**DRAFT**  
**SGS 9 -01**

SGS-9 – June 15-16, 2010

**Global technical regulation No. xx**

HYDROGEN POWERED VEHICLE  
Established in the Global Registry on [DATE]

**Figure 4. Typical Liquefied Hydrogen Storage System**

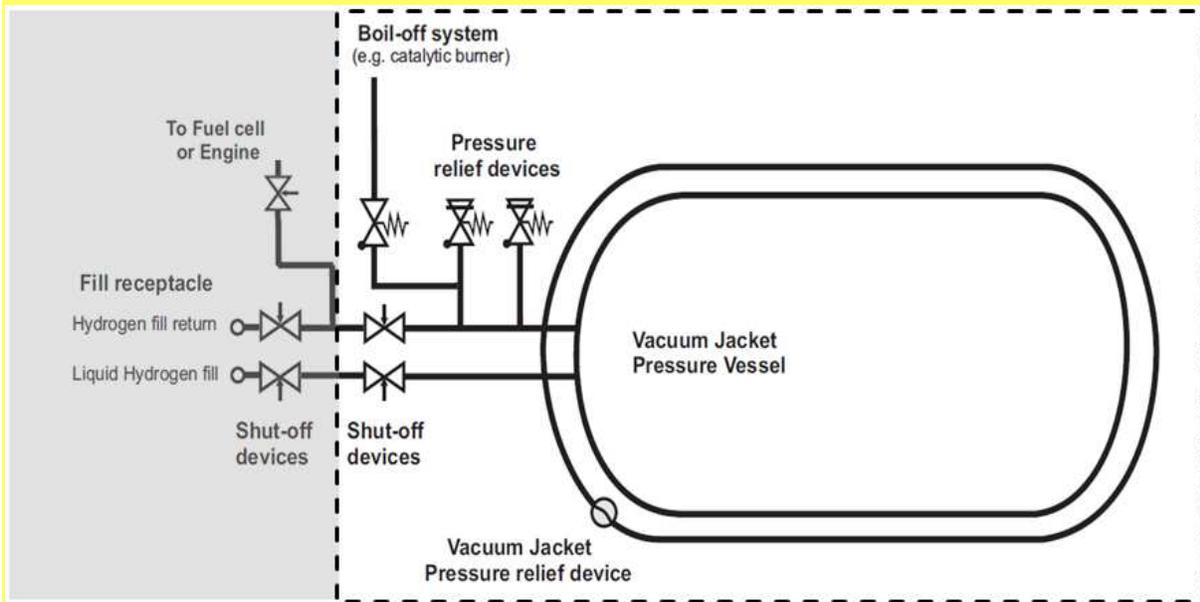
⇒⇒ **SGS-9: BMW proposal:**

⇒⇒ **SGS-8: proposal for deletion of check valve under discussion**

Figure B. 5.1.2 Verification Test for Performance Durability (hydraulic)

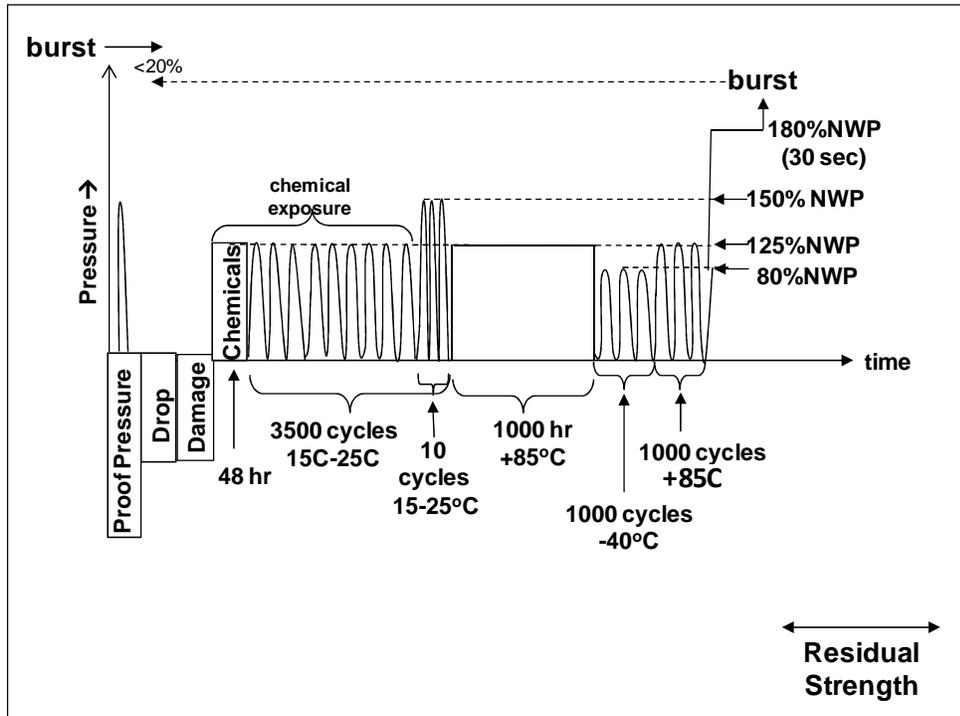
= > = > Germany proposes to replace +50°C by +85°C;

Figure B.5.1.3 Verification Test for Expected On-Road Performance (pneumatic/hydraulic)

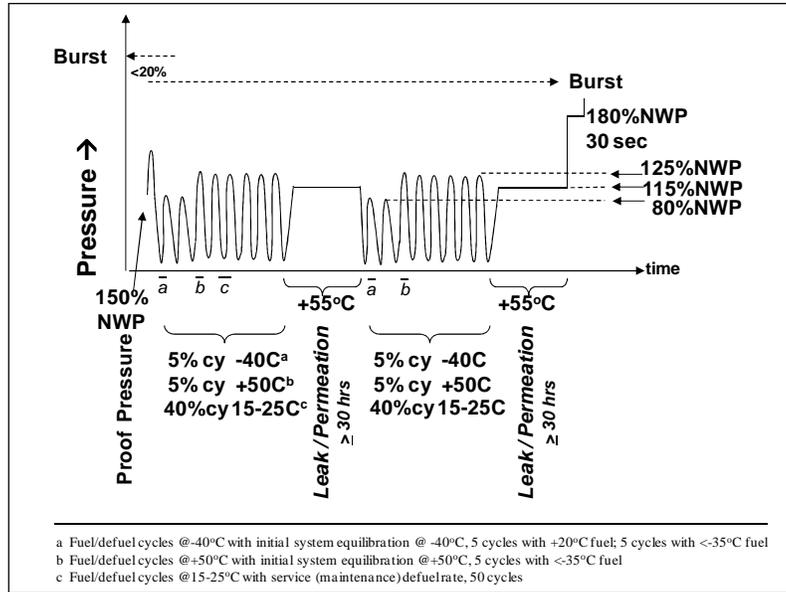
= > = > Germany proposal

▶▶ SGS-9: B.5.1.3.2 text clarified without content change per direction of SGS-8
